**SUBJECT: Transmittal of Westinghouse Responses to Open Items Identified in the AP1000
Draft Safety Evaluation Report**

**Westinghouse Non-Proprietary Response to
AP1000 Draft Safety Evaluation Report (DSER) Open Items**

AP1000 DESIGN CERTIFICATION REVIEW

Figure 220.32-1 Comparison of Capacity Reduction Factors for Tests with Code Case N-284

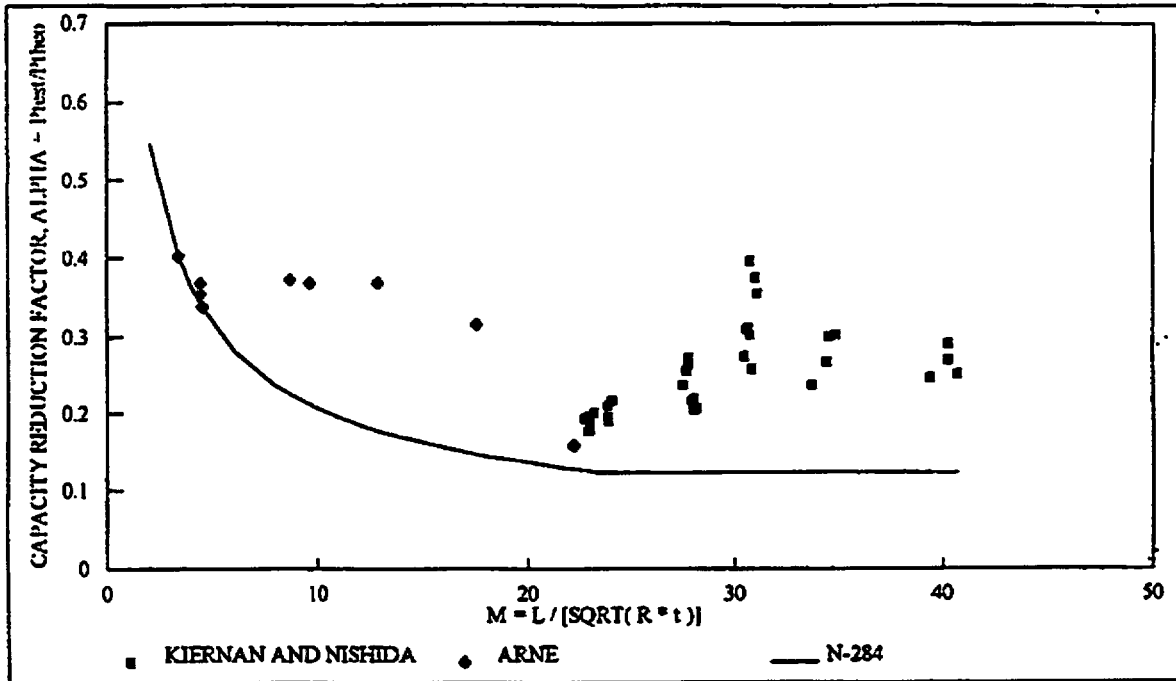
Westinghouse estimates critical buckling pressures for equipment hatches as 196 psig for a 22-foot-diameter hatch and 161 psig for a 16-foot-diameter hatch. The corresponding ASME Level C Service Limits are 117 psig and 96 psig using the Code Case N-284, respectively. From Figure 3.8.2-2, the equipment hatch covers appear convex to the center line of the containment. Therefore, the use of the Code Case N-284 (i.e., the factor of safety of 1.67 for the Level C Service Limit) is not acceptable because the internal pressure of the containment acts as the external pressure to the spherical cap covers and subjects the cap covers to compression. In the case of external pressure, ASME NE-3222 (i.e., the factor of safety of 2.5 for the Level C Service Limit) should be used for the compressive stresses. Note (1) in Table 3.8.2-2 should be revised to reflect the factor of safety of 2.5, or acceptable justification should be provided for not doing so (Section 3.8.2 of the SSAR).

Code Case N-284 provides criteria for evaluation of unstiffened spherical caps subjected to compressive stress due to pressure loading. In the Code Case, the theoretical buckling value is given in paragraph 1712.1.3, the capacity reduction factor is given in paragraph 1512 (b), and the plasticity reduction factor is given in paragraph 1620 and 1610 (a). The capacities of the hatch covers as described in the SSAR are in accordance with this code case.

ASME Code Case N-284 was developed by the code committee based on detailed review and evaluation of test data. Figure 220.32-1 shows test results from references 220.32-1 and 220.32-2 for fabricated steel hemispherical shells and spherical segments. The ratio of test buckling stress to theoretical buckling stress (α) is shown as a function of the non-dimensional unsupported length along the shell ($M = L_1/\sqrt{Rt}$, where L_1 is the unsupported length along the spherical shell, R is the radius of the shell and t is the thickness of the shell). The lower bound curve to these data points, as shown in the figure, is used in Code Case N-284. For the AP600 16 foot diameter equipment hatch, $M = 14.5$, and the capacity reduction factor, corresponding to α in the figure, is 0.167. The stresses in the hatch cover are well below yield and the plasticity reduction factor is unity. The test data for shell lengths of 10 to 20 show capacities significantly above those of the Code Case. The capacity of the hatch covers, as calculated by the ASME Code Case, corresponds to the lower bound of the test data. As a result the 1.67 factor of safety specified in paragraph 1400 of the ASME Code Case is considered appropriate for calculating the Service Level C pressure capacities of the hatch covers.
